Proposal #31: 1600-15-70, WISC 2026118
Clintonville – Wittenberg,
CTH C to Gollnow Road
USH 45
Waupaca & Shawano County

This is Addendum No. 02, which provides for the following:

ADDENDUM NO. 02

Addendum No. 02
ID 1600-15-70
Added Sheet 29A
December 2, 2025

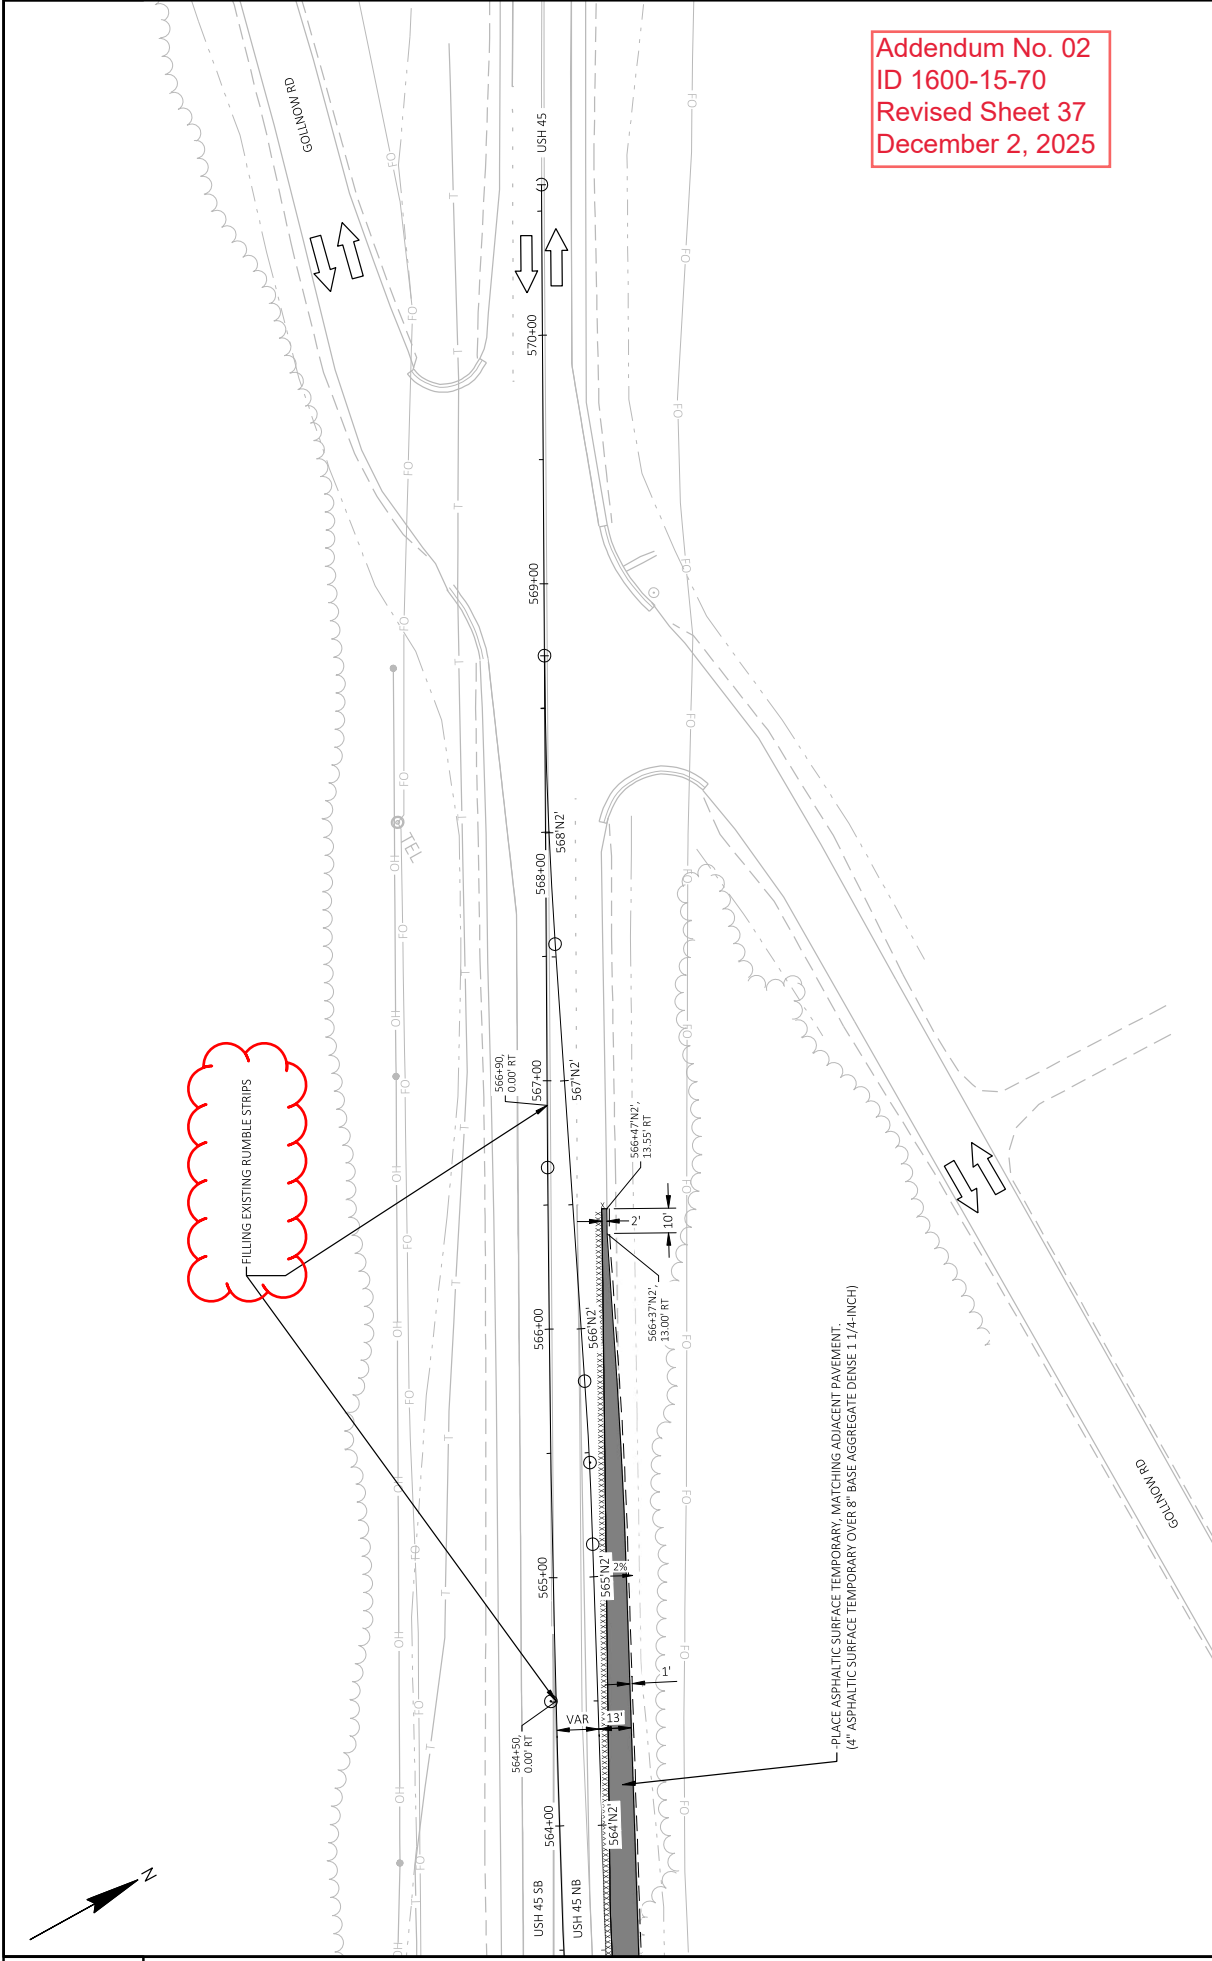
Added Plan Sheets	
Plan Sheet	Plan Sheet Title (brief description of why sheet was added)
29A	Construction Detail (New Detail)

MILL EXISTING ASPHALT AND FILL WITH ASPHALT SURFACE
MATCH EXISTING PAVEMENT CROSS SLOPES

FILLING EXISTING RUMBLE STRIPS DETAIL
STATION 564+50 TO STATION 566+90

Mill out existing rumble strips and replace with asphaltic surface in the locations identified in the plans. Complete this work prior to shifting traffic and resurfacing.

Mill, clean, tack and place new HMA material as identified in the plans. Conform to standard spec 455.3 and 465.3.
